## Service Bulletin

No. : MZ04-035

**Model:** SR8300/SR9300

**Subject:** SETUP sometimes returns to initial setting.

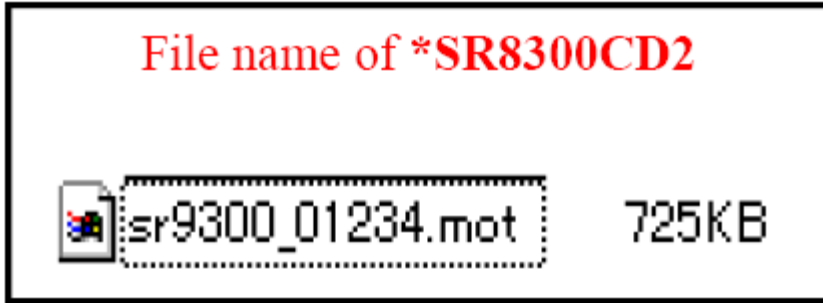
1. Model Name is displayed like "SR9200", "SR8200", "PS9200:."
2. Software version of QU01(CPU) is displayed in the following format.

M	A	I	N	V	0	0	0	4	2	6		0	U
				[Year]	[Month]	[Date]			No	Ver.

V030123 4
